Consultation Responses on Revised Submission

Historic England

The Cathedral and City Centre Conservation Area was designated in 1968, and 27-29 Clasketgate lies on a corner plot bounded by Clasketgate and Flaxengate within this designated area. The building which is thought to date from the early C18 (HER entry) is a non-designated asset which, in our view, makes a positive contribution to the character and appearance of the conservation area as an early C18 building of townscape merit. The rear range in particular has a steeply pitched roof which indicates an early form.

DRAWING 1 - HEIGHT PARAMETERS

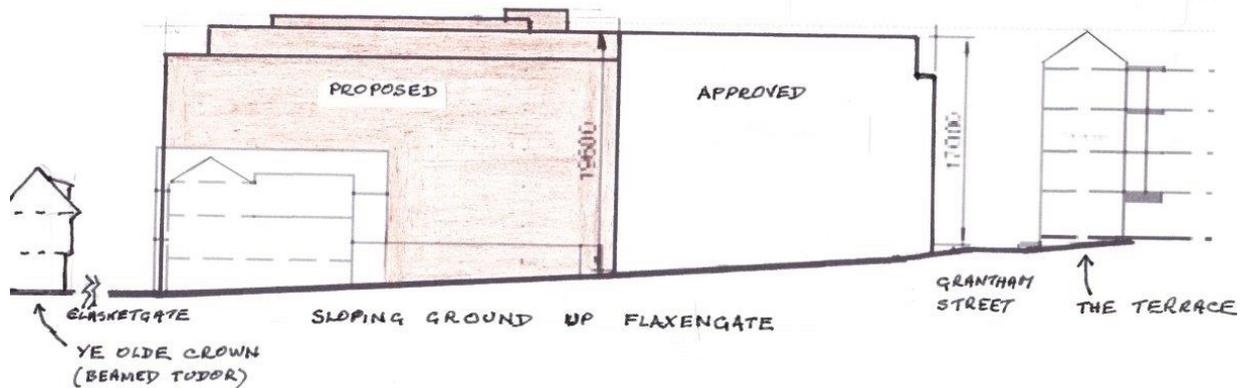
Drawing 1, - Height Parameters

- Flaxengate slopes down steeply, and drops approximately 3 storeys from The Terrace on the uphill side of Grantham Street down to Clasketgate

- This drawing shows how the proposed development joins to the approved development on Grantham Street to form a continuous wall.
- Members will note that the approved block has a roof level just under the roof height of the Terrace, but that the developers did not make any reduction in height to reflect the sloping ground down Flaxengate

- The proposed development has been continued at this same roof line, again with no allowance for sloping Flaxengate. Consequently, the frontage onto Clasketgate which continues the roof level of the 4-storey Terrace block is about 3 storeys higher than The Terrace frontage.

- There is no information on Lincoln City Council's Planning website about the top storey, Level 7, of the development. However, it appears that it may be a luxury pent house suite, glazed all round with curtain walling, plus a roof top terrace with safety screens which are higher than the roof line of the approved development. Rising still higher above this roof line is a structure which presumably is to give access to the roof top terrace. The result is that this rises almost to 8 storeys above street level.

DRAWING 3 - AT JUNCTION
OF FLAKENGATE WITH CLASKETGATE

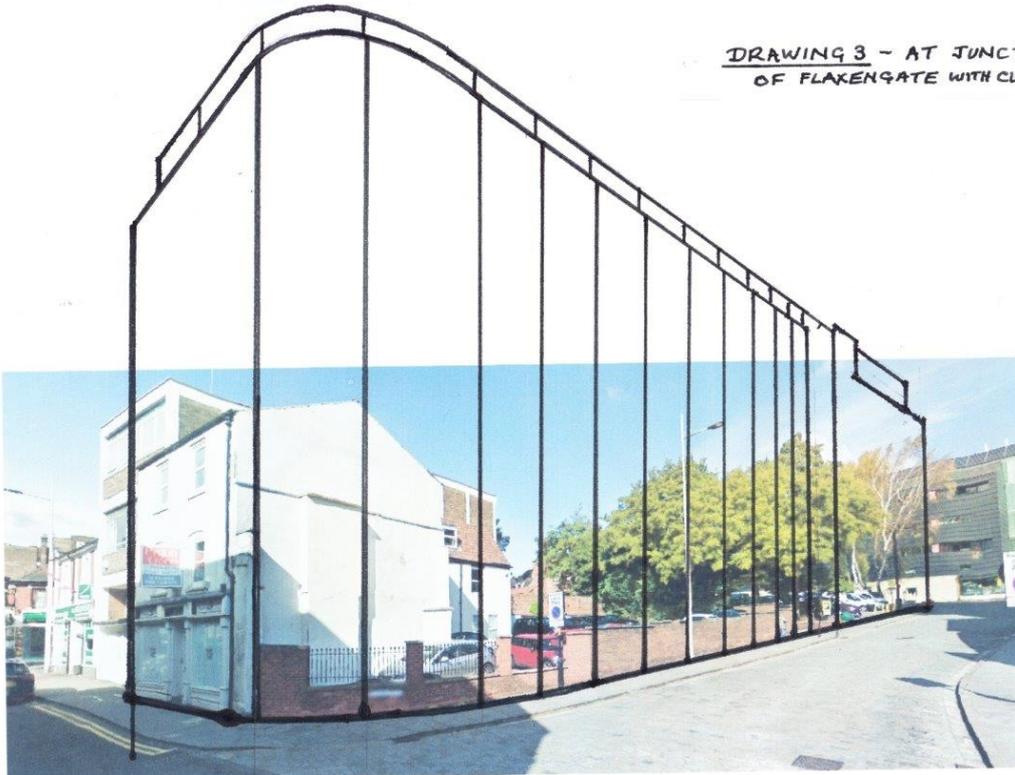
Drawing 3, - Line Drawn Visual looking from the junction of Flaxengate with Clasketgate

- This drawing clearly shows the overpowering scale of the proposed development, and the intimidating effect of the continuous tall façade from Clasketgate up the hill to Grantham Street.

DRAWING 2 - CLASKETGATE LOOKING EAST
FROM SWAN STREET

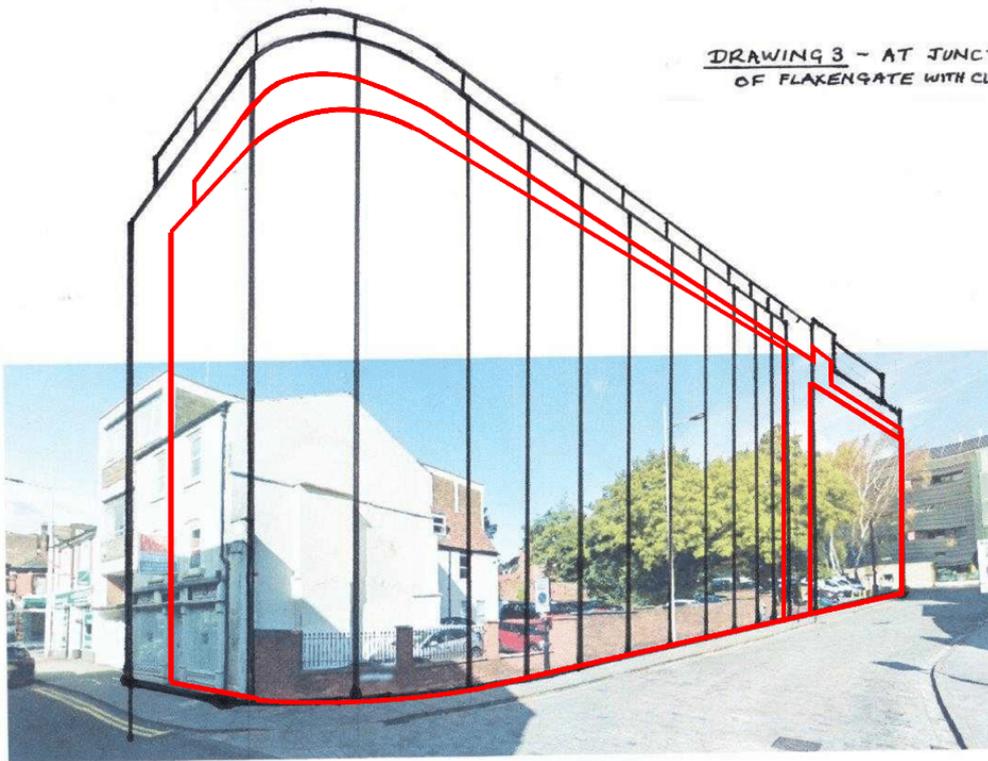
Drawing 2, - Line Drawn Visual of Clasketgate looking east from Swan Street

- This drawing shows how the development will dominate and overpower the predominately 2 and 3 storey buildings adjacent
- Notice the impact it will have on the Tudor beamed tavern – Ye Olde Crown, which is immediately opposite.
- The development will also be a discordant intrusion when viewed from longer distances along Clasketgate, both east and west
